**Observation Report  
of the  
Electrical services  
for  
Turtle Cove Condominium Association  
1213 Linda Road, Okeechobee, Florida 34974**

**Issued: February 17, 2026**

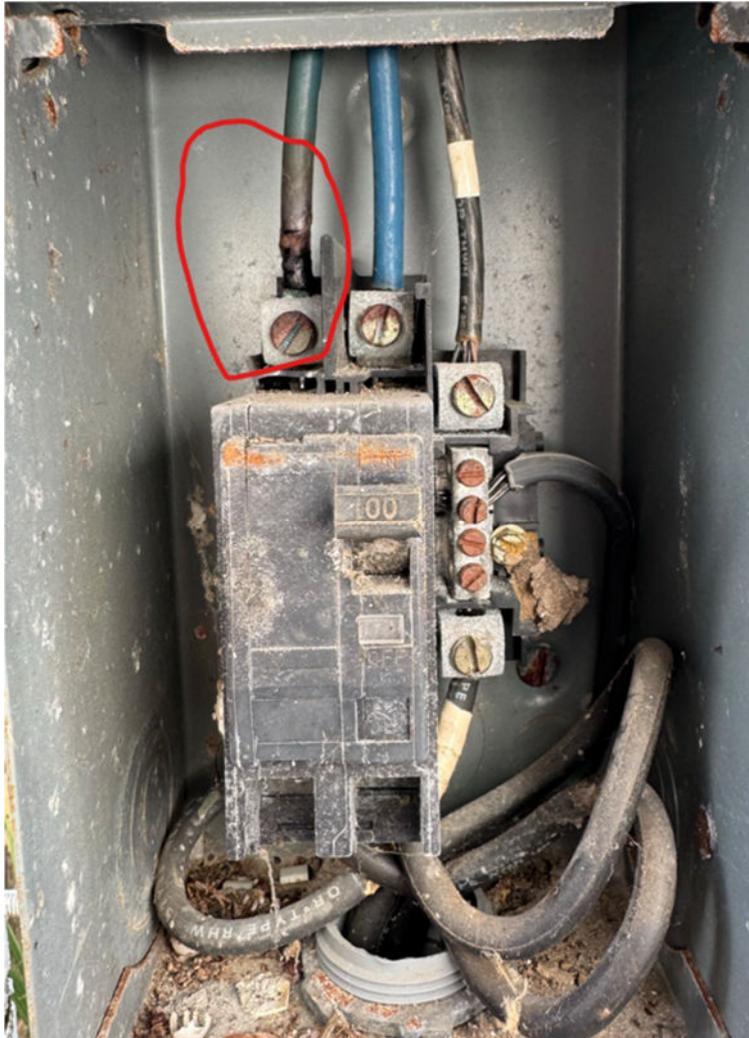
4. **Observation:** Many of the original 60-amp breakers have been switched out for larger 100-amp breakers. These exceed the rating of the breaker box and the #6 wire. Breakers shall not exceed conductor ampacity per NEC 240.4. Also violates panel labeling/max rating (70 A noted). Immediate hazard per NEC 110.3(B) (listed equipment use).

5. **Observation:** Evidence of thermal damage indicates high-resistance terminations or overload.

**Recommendation:** Replace these with 60-amp breakers immediately.

**Recommendation:** Recommend an infrared scan (if not already done) and replacement per NEC 110.14 (electrical connections) and NEC 110.12 (neat/workmanlike).

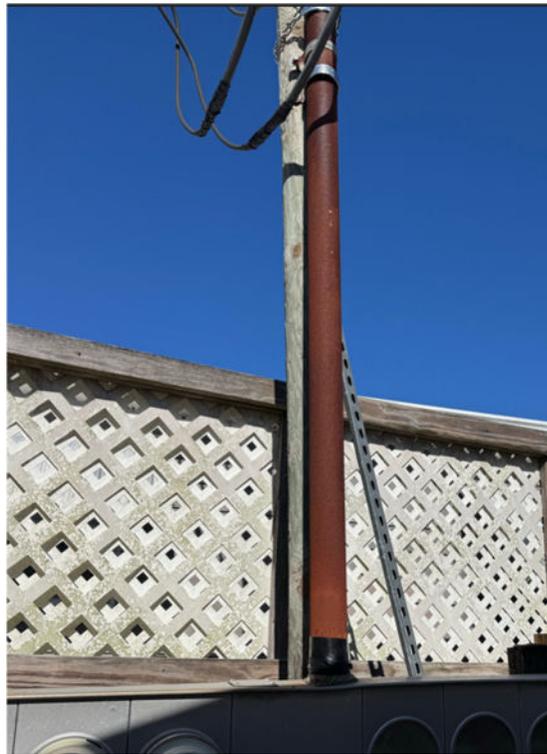
6. **Observation:** Some weather head masts are under strain from overhead lines. Causing bending, flexing, and damage to the threaded connection to the meter cans. Weather head strain risks conductor damage/failure per NEC 230.28 (service masts).

- 7. Observation:** Meters and mains are mounted on stanchions constructed of wood and steel Unistrut. Wood stanchions, masts, and Unistrut are in varying degrees of disrepair. Many have been jerry-rigged in an attempt to secure the structures. Jerry-rigged supports violate NEC 110.12.

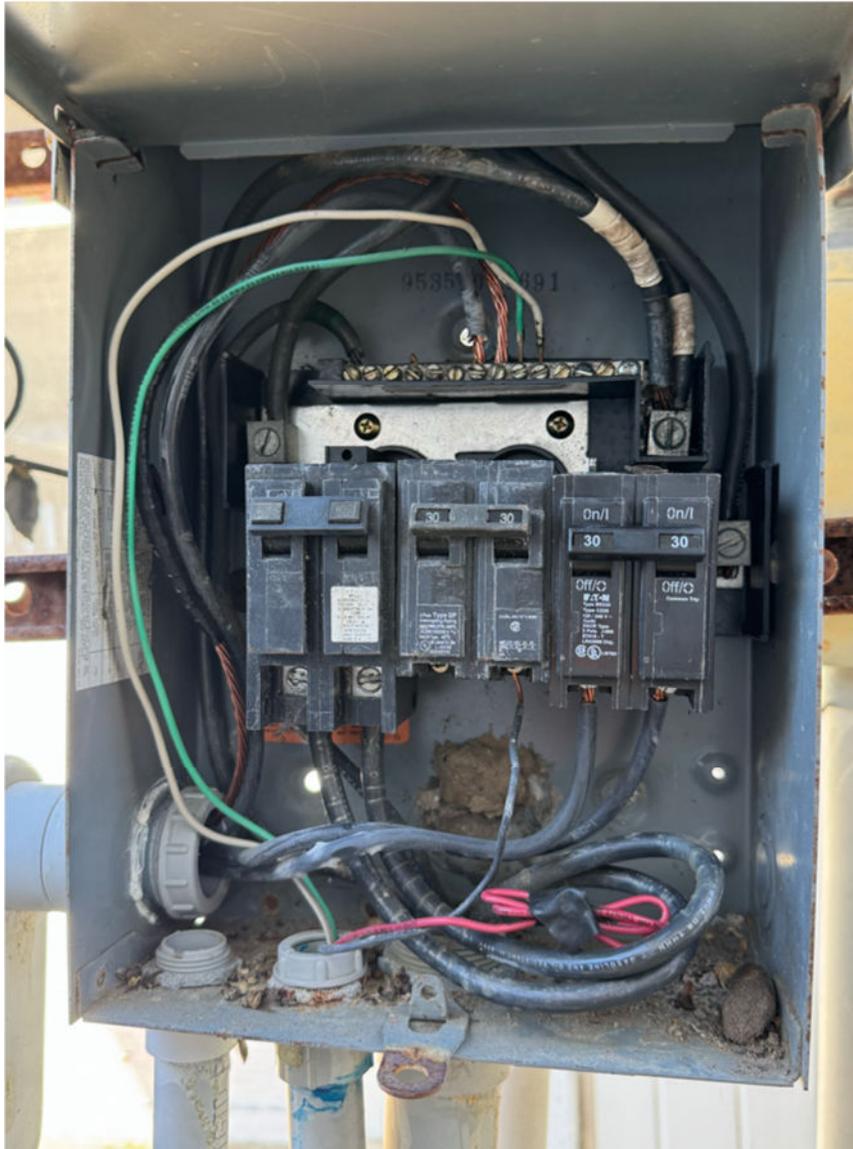
- 8. Observation:** Some mains have been replaced with sub-panels with multiple breakers. The panel below has an undersized wire (#14) connected to a two-pole breaker (30-amps). #14 AWG on 30 A breaker violates NEC 240.4(D) (small conductor rule: #14 copper max 15 A) and NEC 240.4.

**Recommendation:** Replace the breaker with the correct size.
